NL-15-094

SUBJECT: Proposed Changes to Indian Point Unit 3 Technical Specifications Regarding
Reactor Vessel Heatup and Cooldown Curves and Low Temperature Overpressure
Protection System Requirements
Indian Point Unit No. 3
Docket No. 50-286
License No. DPR-64

REVISED MARKUP OF TECHNICAL SPECIFICATION PAGES FOR PROPOSED CHANGES REGARDING REACTOR HEATUP AND COOLDOWN CURVES AND LTOP REQUIREMENTS

Text changes indicated by lineout for deletion and Bold/Italics for additions
Figure changes are marked with either "Replace with New Figure" or "Delete this Figure" and all
new Figures are unmarked

Figure 3.4.3-1:

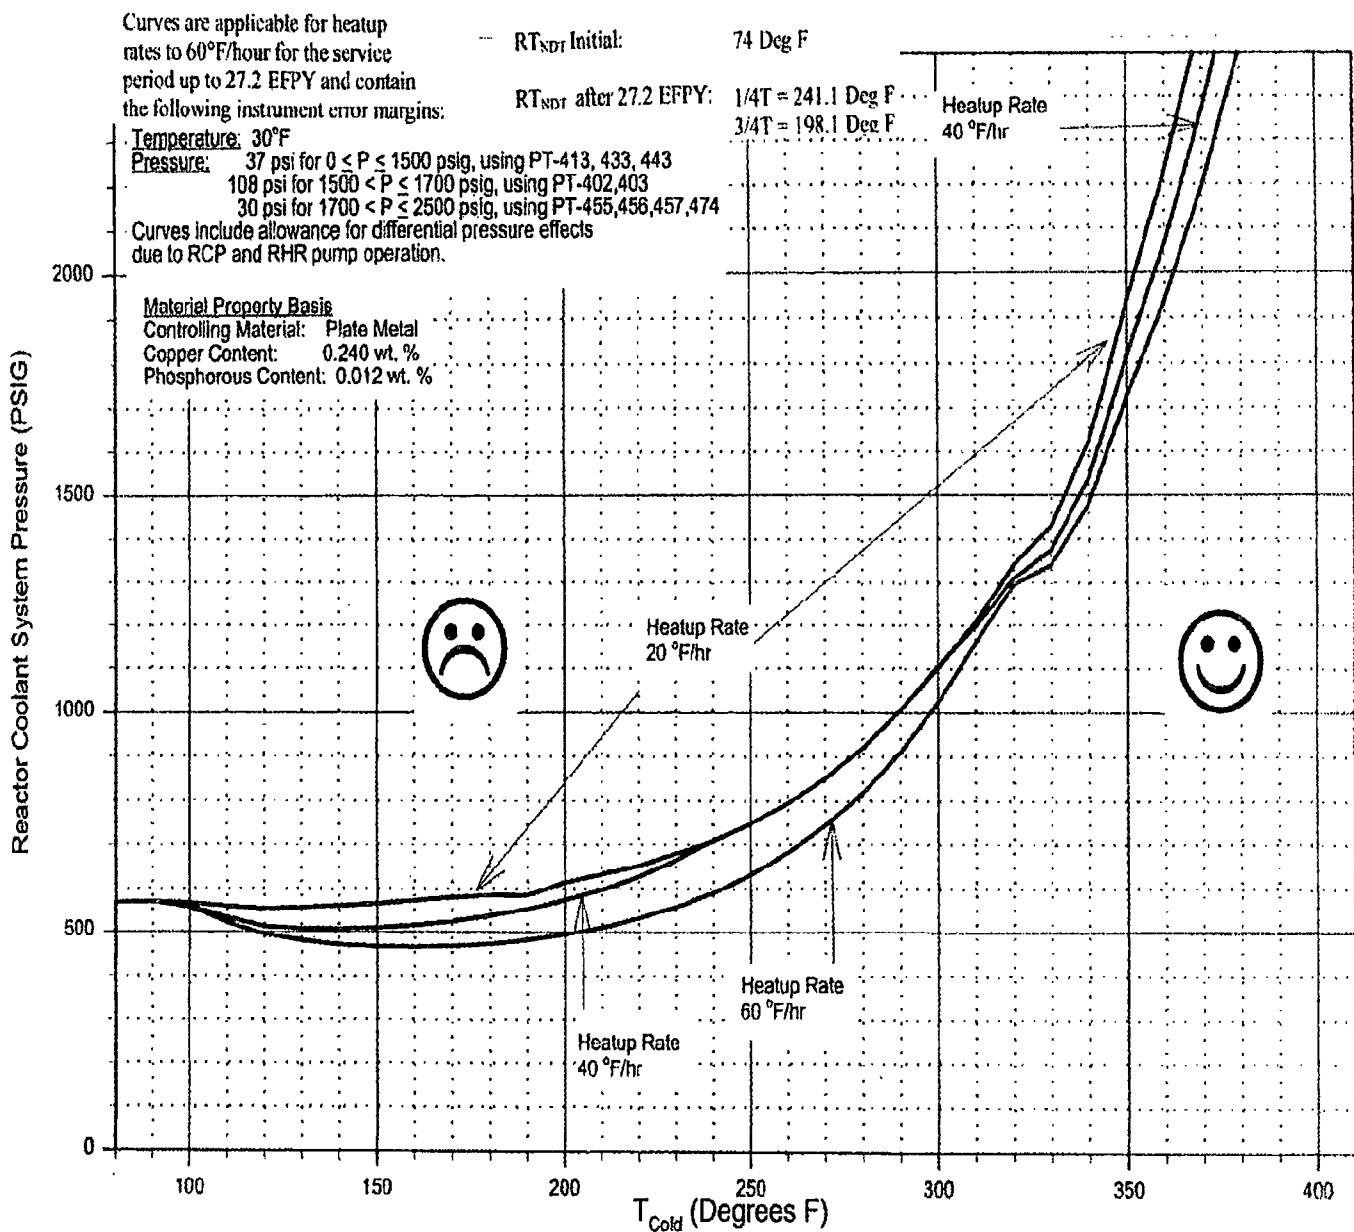
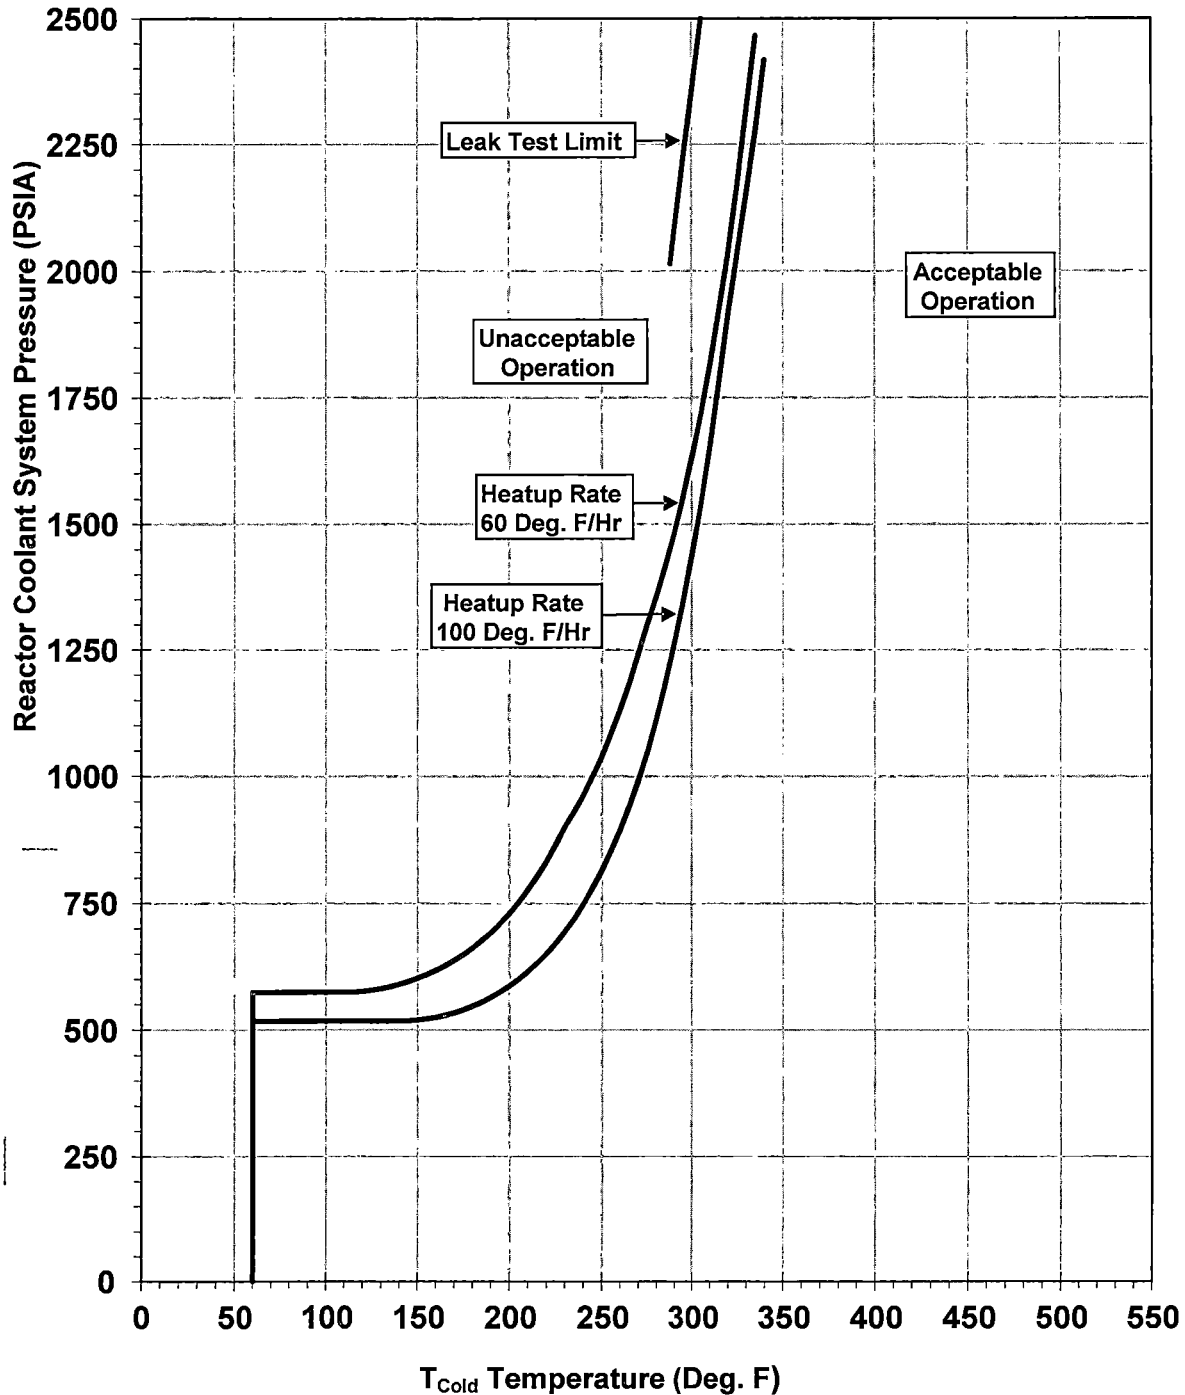
REPLACE WITH NEW FIGURE

Heatup Limitations for Reactor Coolant System

Figure 3.4.3-1:
Heatup and Inservice Leak Test Limitations for Reactor Coolant System
(Without instrument uncertainties)

Figure 3.4.3-2:
Cooldown Limitations for Reactor Coolant System

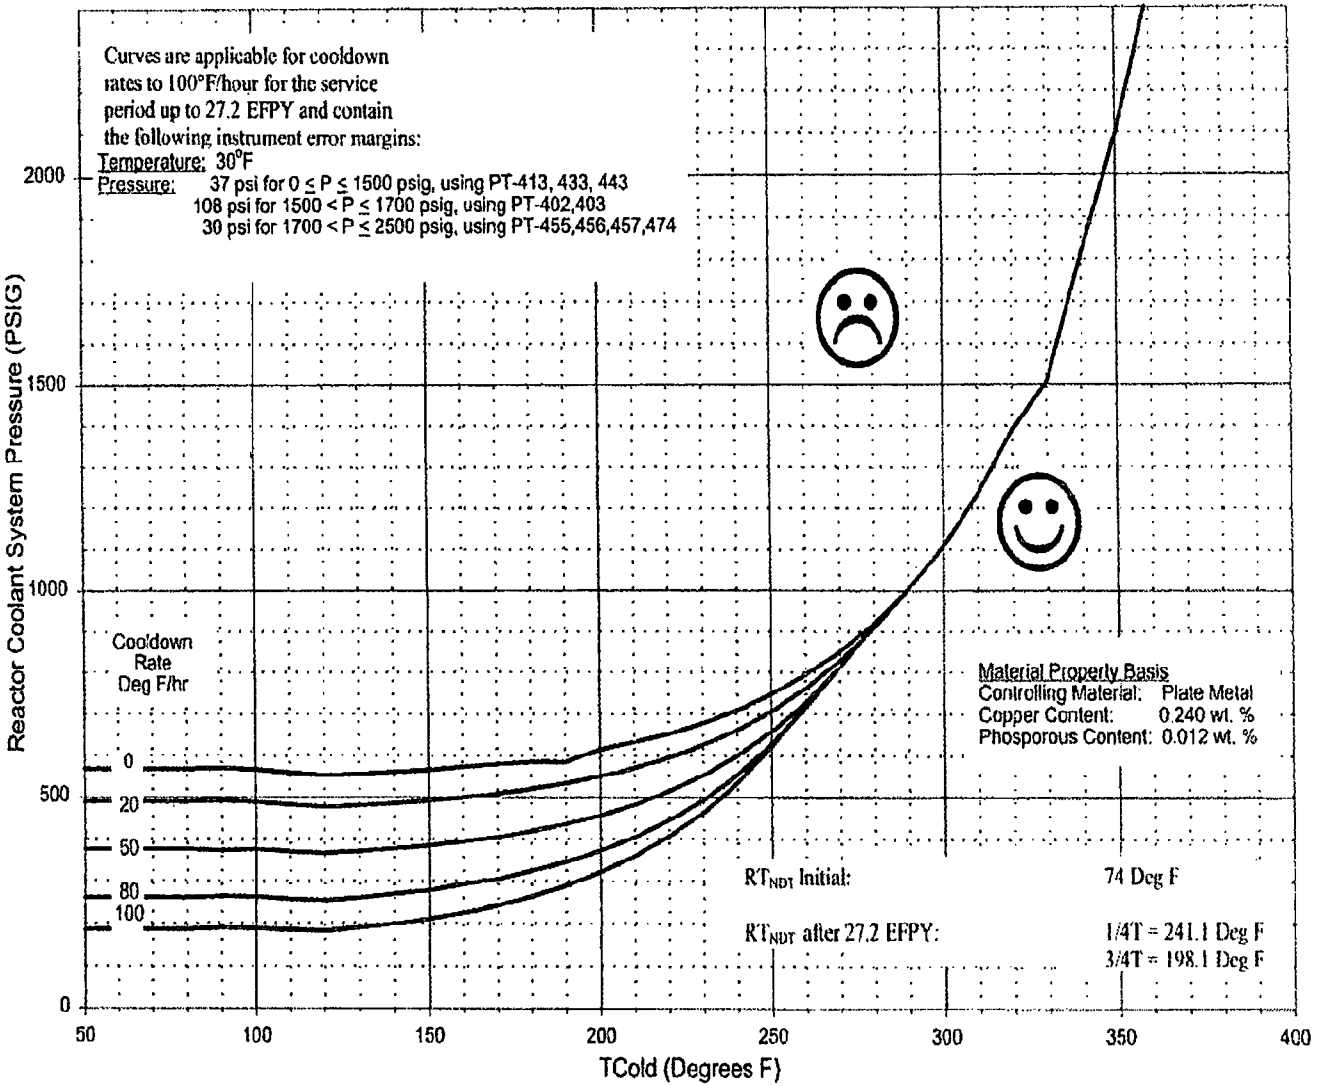
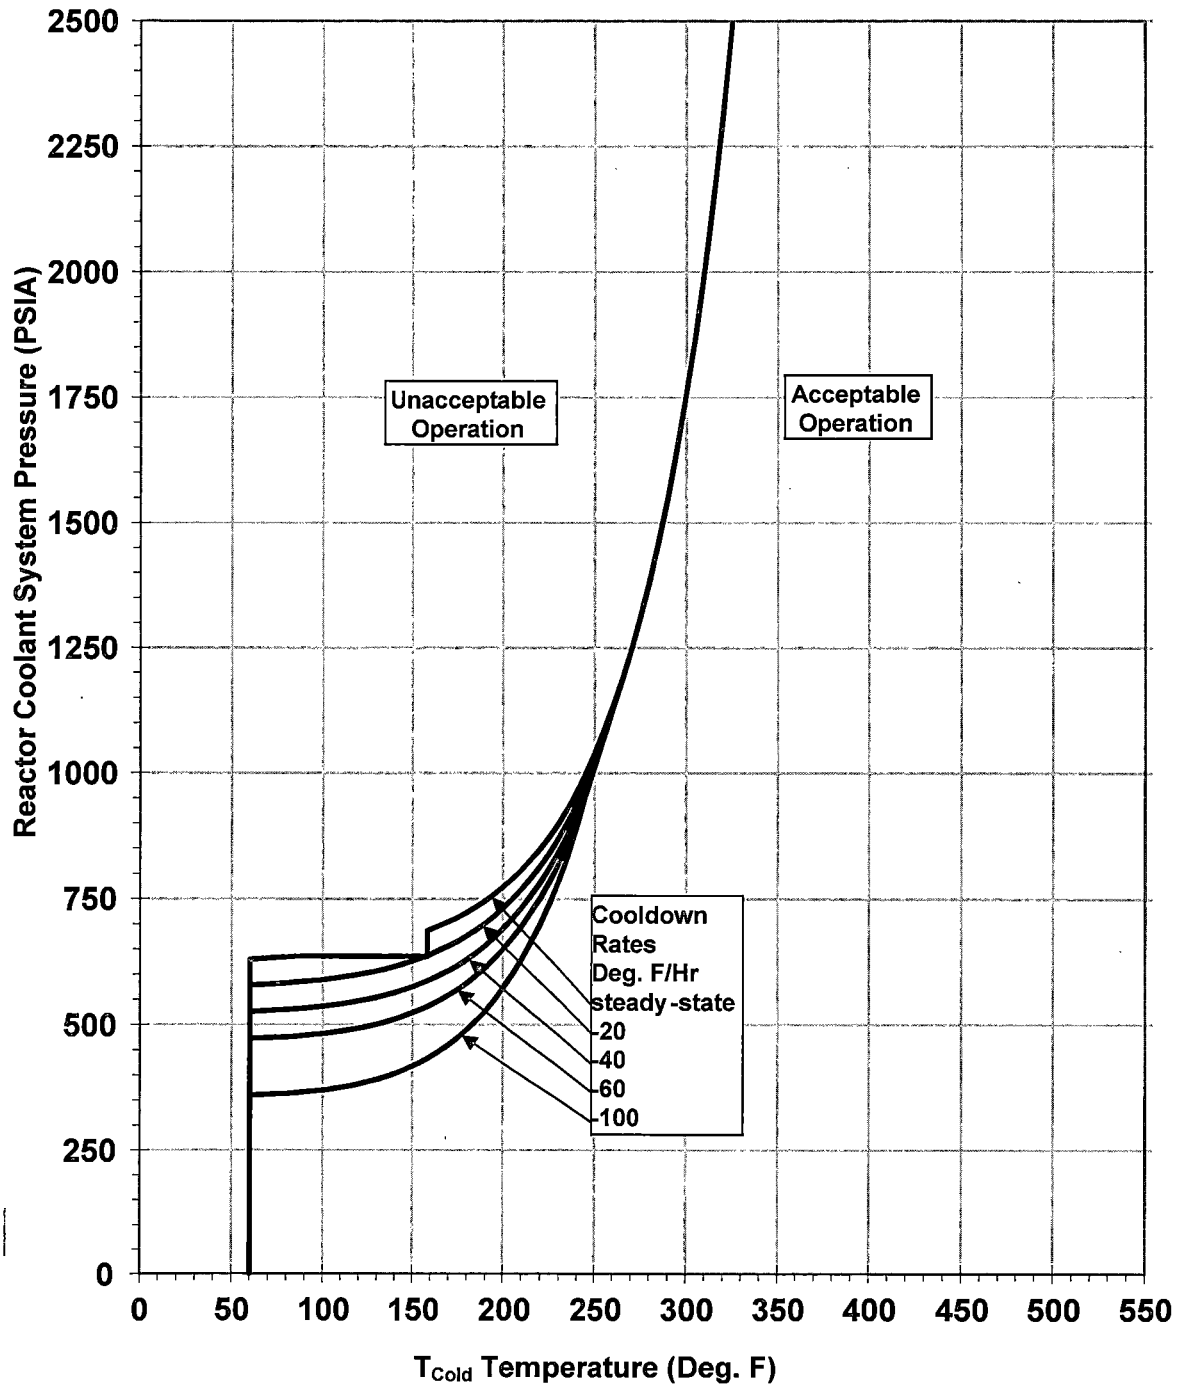
REPLACE WITH NEW FIGURE

Figure 3.4.3-2:
Cooldown Limitations for Reactor Coolant System
(Without instrument uncertainties)

Figure 3.4.3-3:

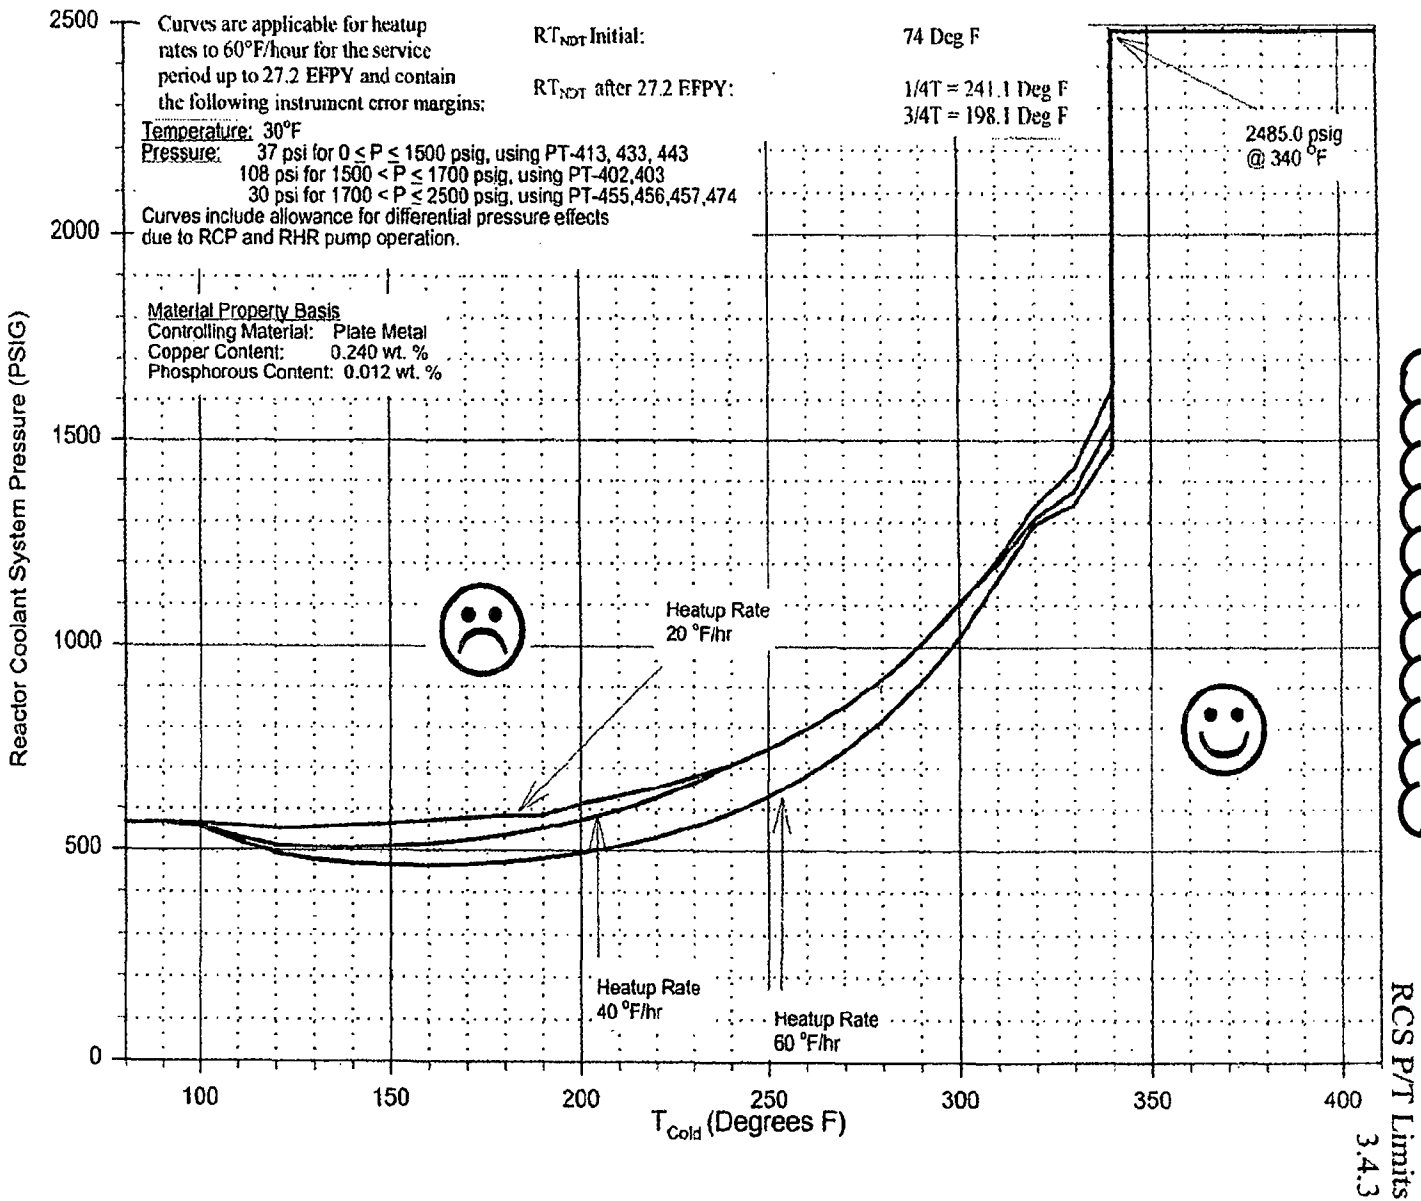
LCO 3.4.3 RCS pressure, RCS temperature, and RCS heatup and cooldown rates shall be maintained within the limits specified in Figure 3.4.3-1, **and** Figure 3.4.3-2, and ~~Figure 3.4.3-3.~~

Figure 3.4.12-2: Pressurizer Limitations for OPS Inoperable, 27.2 EFPY
 (Up to one charging pump capable of feeding the RCS)

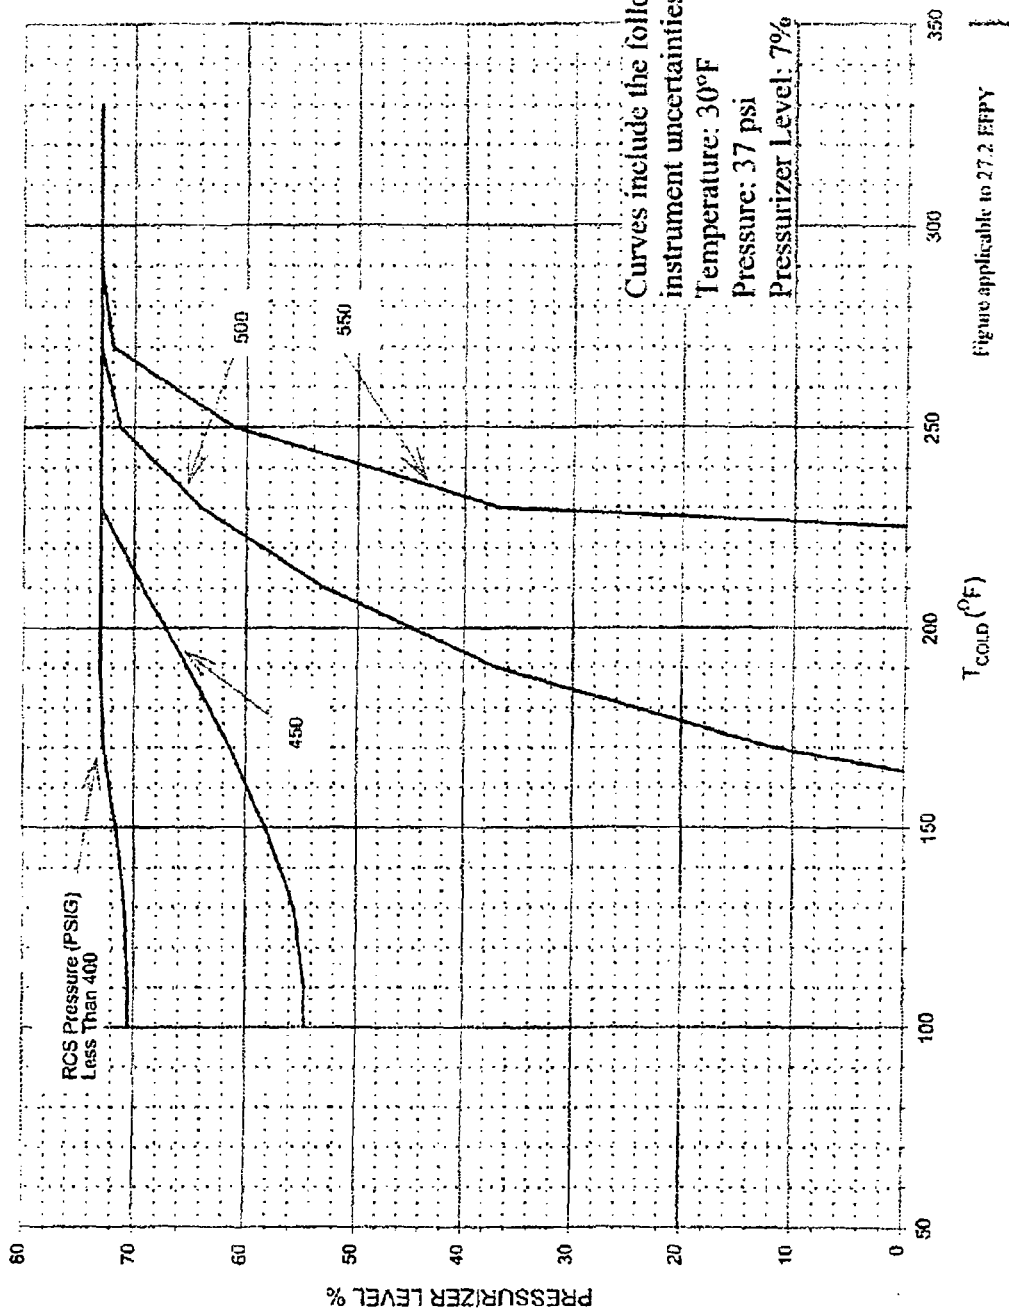
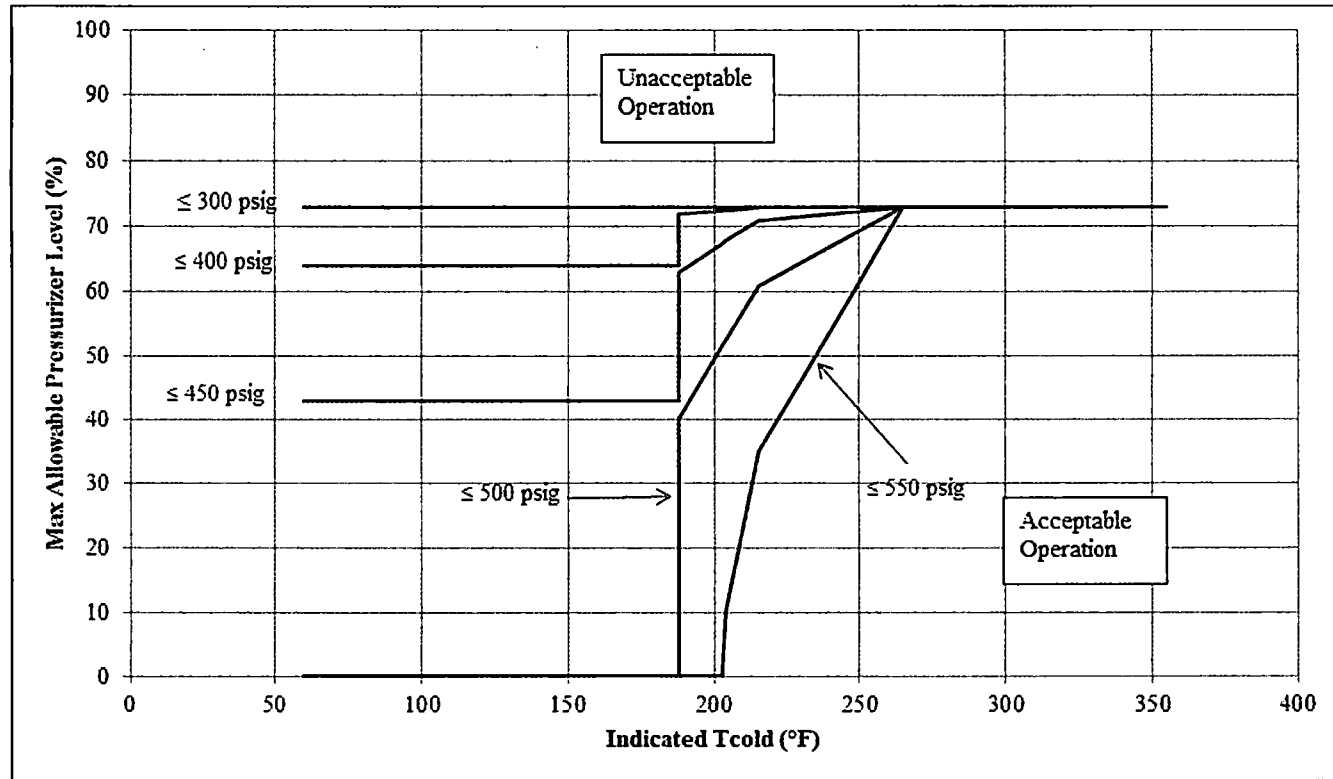
REPLACE WITH NEW FIGURE

Figure 3.4.12-2: Maximum Allowable Pressurizer Level for LTOPS Inoperable with 1 Charging Pump Capable of Injecting, 37 EFY
